TOMBALL INDEPENDENT SCHOOL DISTRICT

RFP/CSP #1002-26 Issued: June 5th, 2026
REQUEST FOR COMPETITIVE SEALED PROPOSALS
FOR THE CONSTRUCTION OF A NEW
HVAC Control System at the Tomball High School

Addendum No. 03

July 22nd, 2026

DATE: 05/29/2026
DRAWN BY: DBR
CHECKED BY: DBR
PROJECT NUMBER 260018.001
SHEET TITLE: MECHANICAL CONTROLS DIAGRAMS
SHEET NUMBER: M7.01

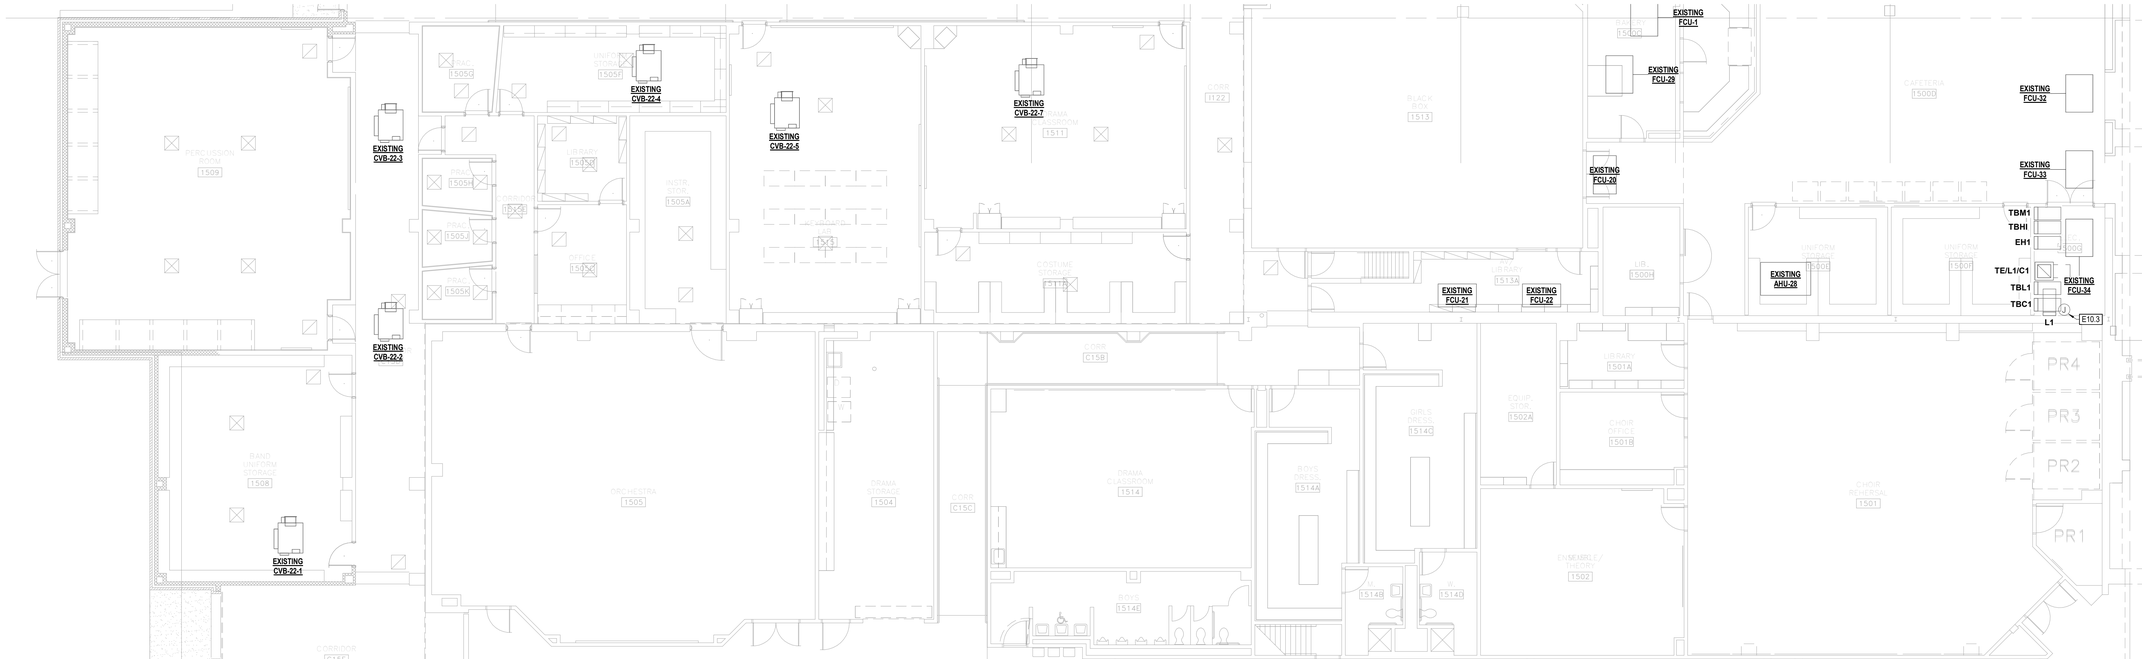
Item 17 Sheet M7.01 – MECHANICAL CONTROL DIAGRAMS

SHEET NUMBER: E2.21I

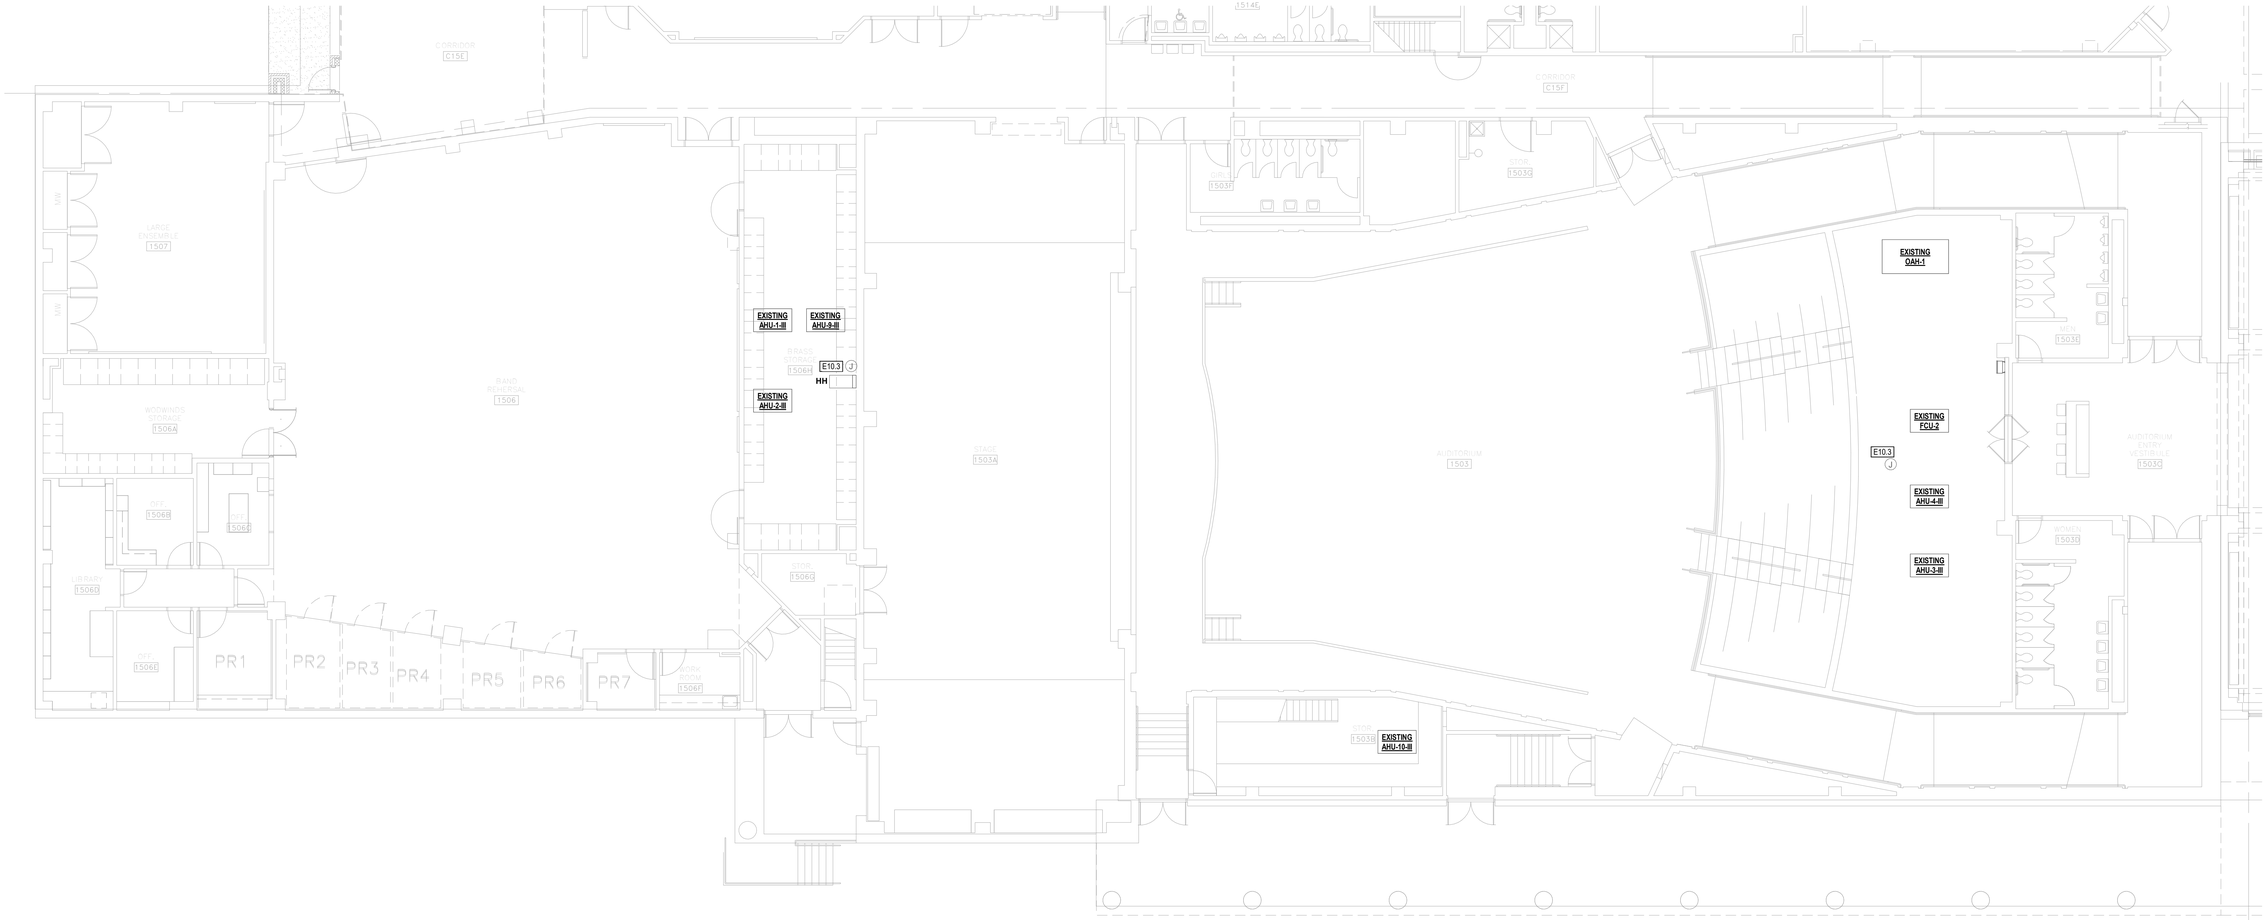
Item 18 Sheet E2.21I – ELECTRICAL POWER PLAN LEVEL 1 - AREA I

A. Added new sheet in its entirety. Sheet shows location of existing lighting controls and is tagged with keyed note E10.3. Location of existing lighting controls was based on existing controls as-builds.

SHEET NUMBER: 1 E2.21L

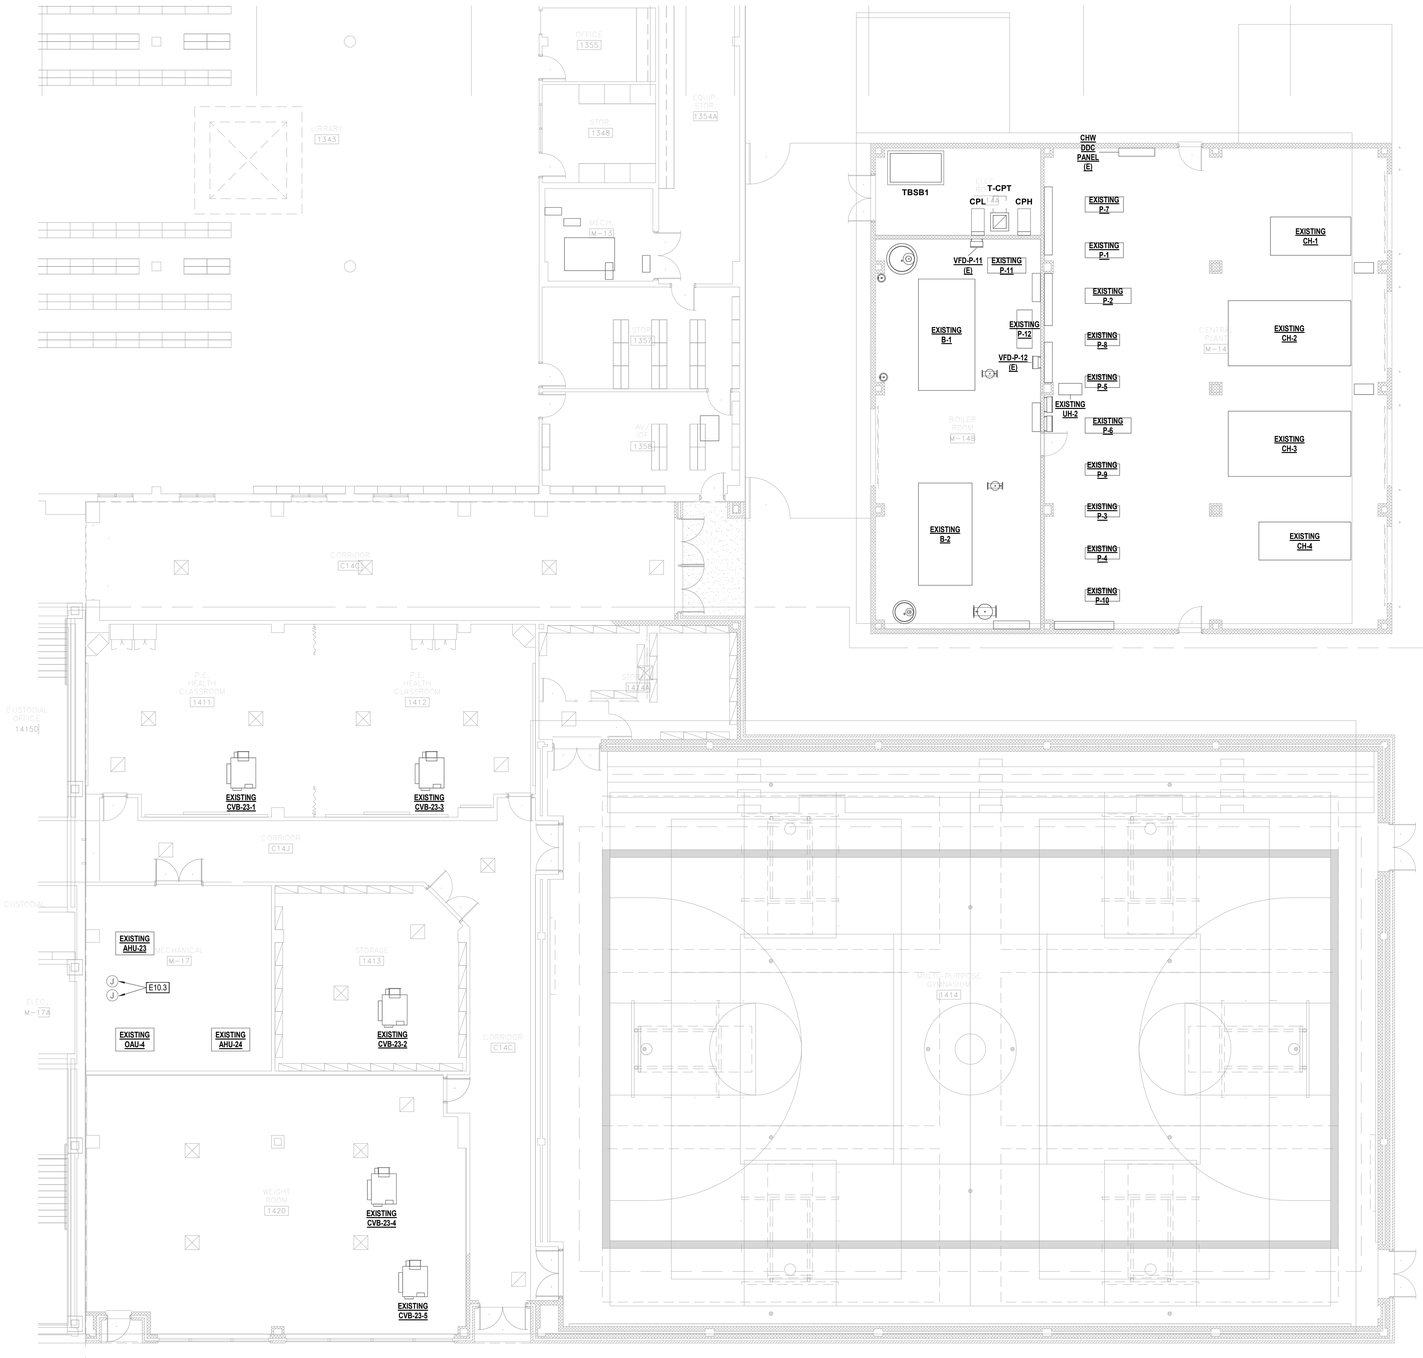
Item 19 Sheet E2.21L – ELECTRICAL POWER PLAN LEVEL 1 - AREA L

A. Added new sheet in its entirety. Sheet shows location of existing lighting controls and is tagged with keyed note E10.3. Location of existing lighting controls was based on existing controls as-builds.
